VIRGINIA ELECTRIC AND POWER COMPANY
RICHMOND, VIRGINIA 23261

March 9, 1983

Serial No. 085C
PSE/JEW:nh
Docket Nos.: 50-280
50-281
License Nos.: DPR-32
DPR-37

TECHNICAL EVALUATION REPORTS
ENVIRONMENTAL QUALIFICATION OF SAFETY RELATED ELECTRICAL EQUIPMENT
SURRY POWER STATION UNITS 1 AND 2

FIGURE 10
(CERRO. 1000V XLPE INSULATED CABLES)

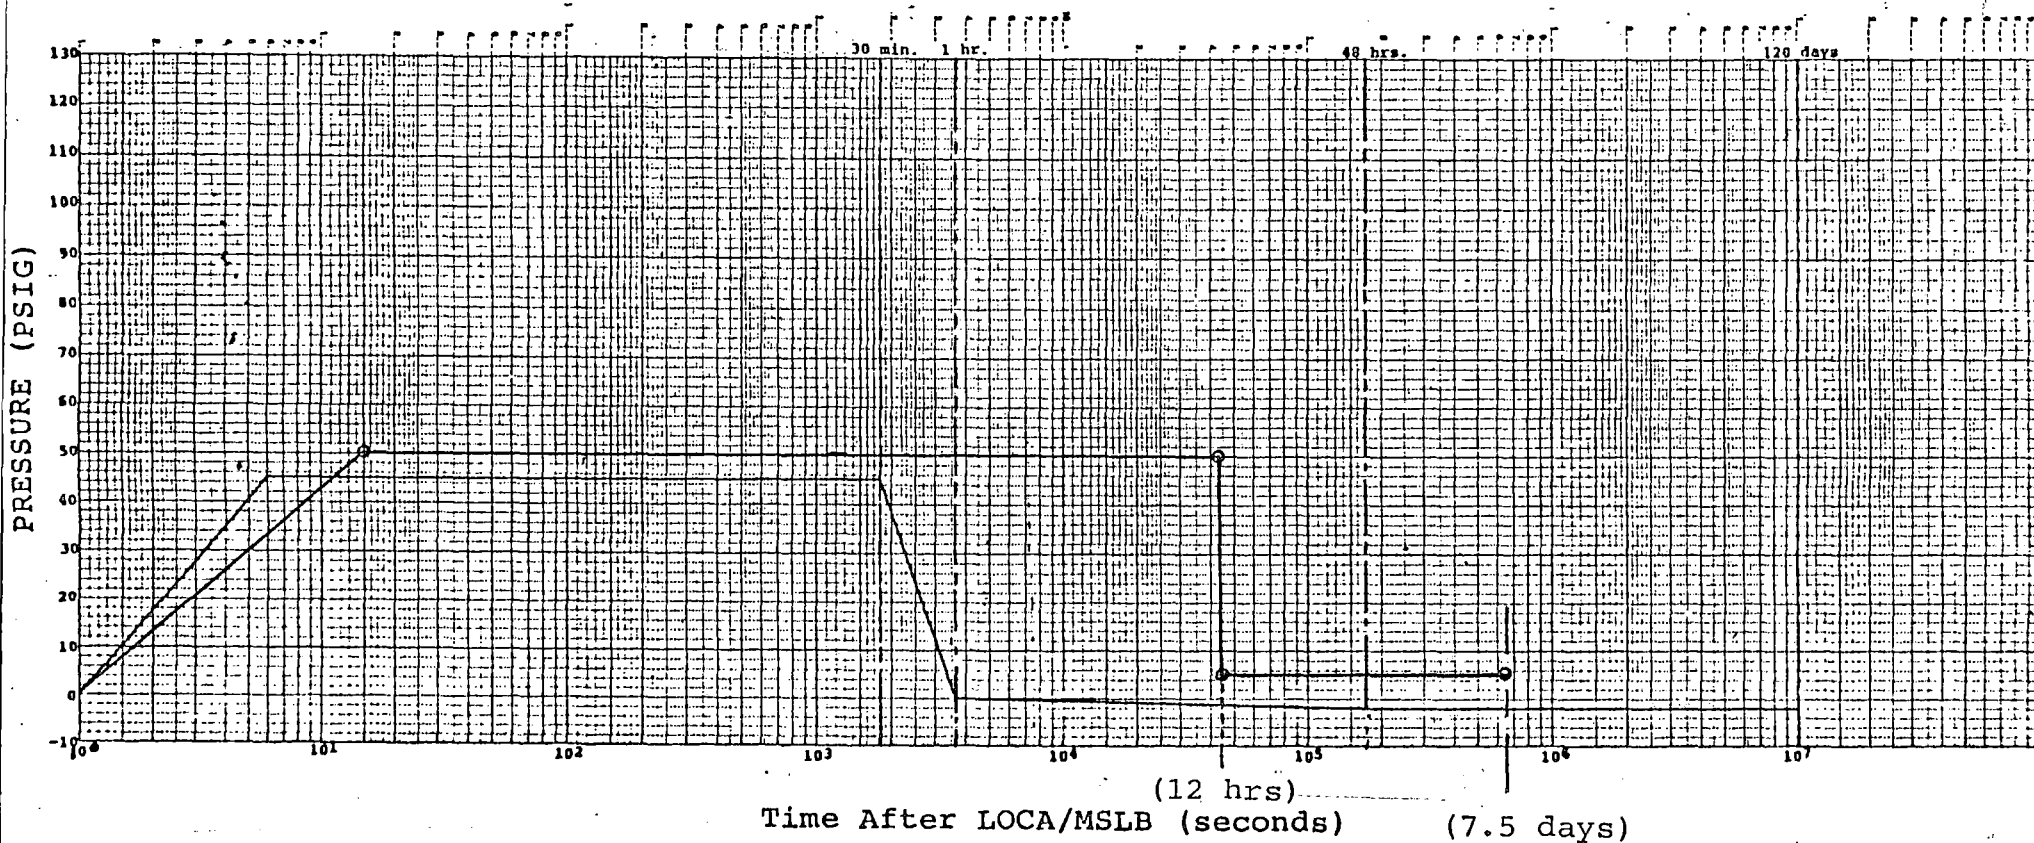
As evident from the Fig. 10 the plant ambient temperature falls to 150°F after one hour and to 120°F after 48 hours. For conservatism we assumed 150°F LOCA temperature for all the 120 days of LOCA.

Considering the above it is concluded that the conducted test is more severe than the required conditions of the plant.

FIGURE 10

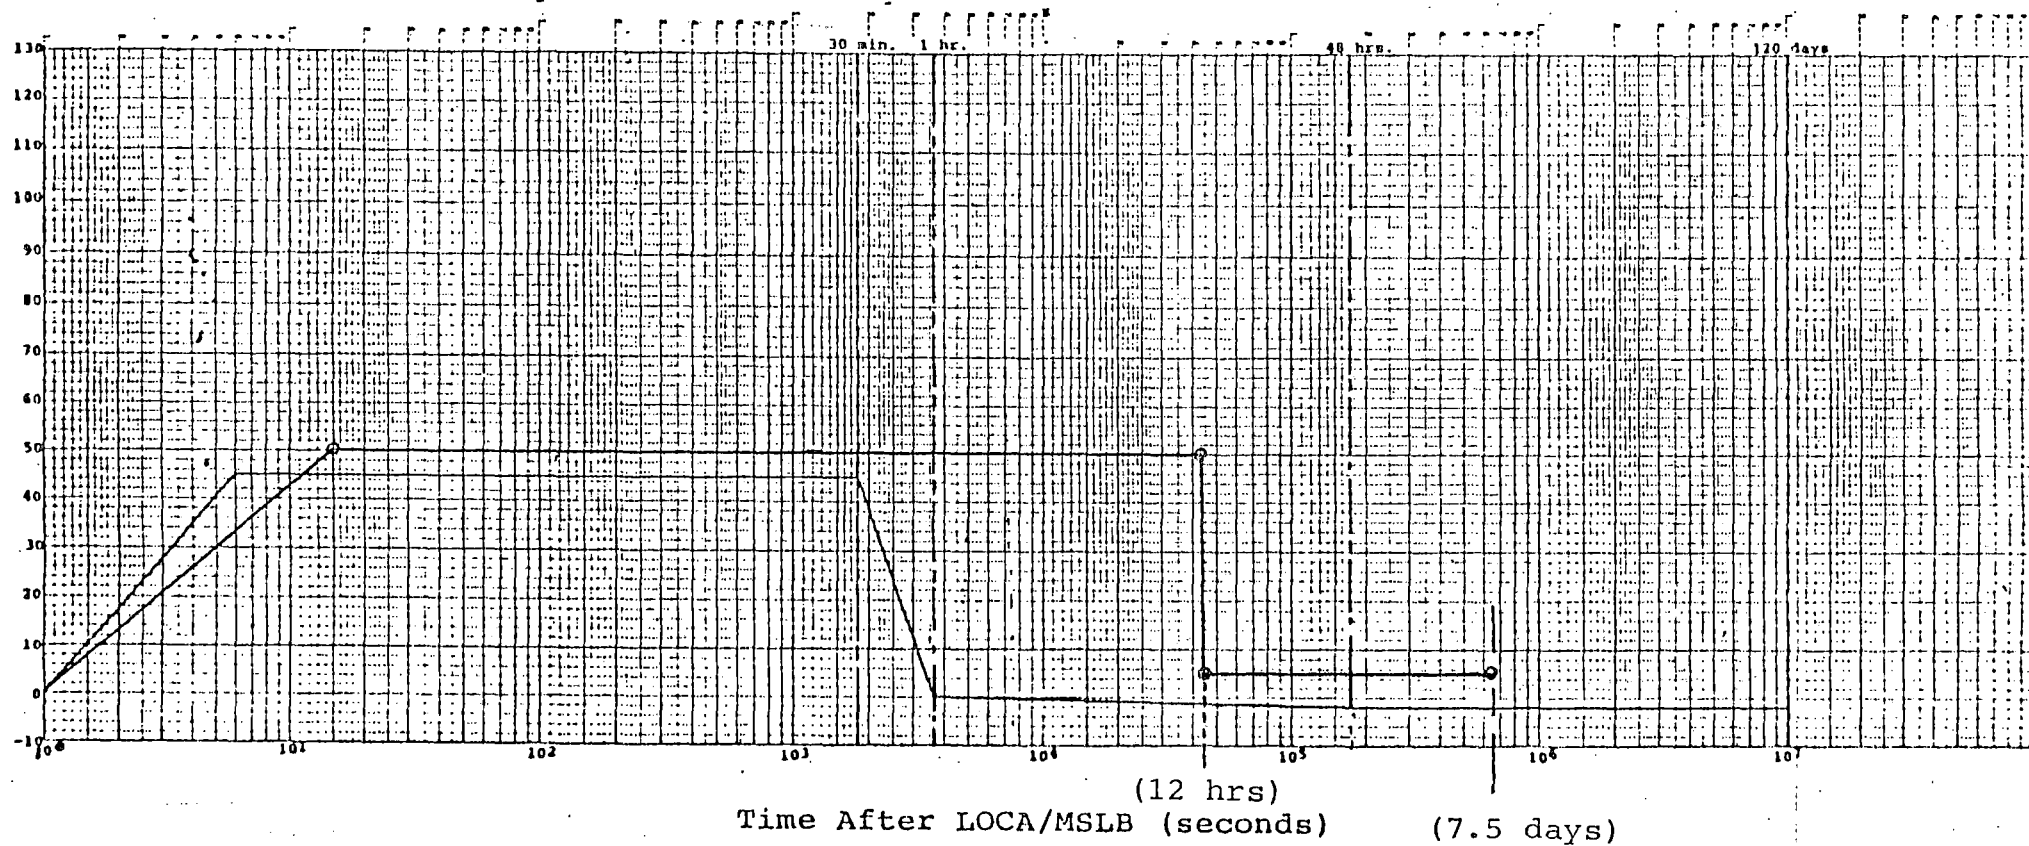
As evident from the Fig. 10 the plant ambient temperature falls to 150°F after one hour and to 120°F after 48 hours. For conservatism we assumed 150°F LOCA temperature for all the 120 days of LOCA.
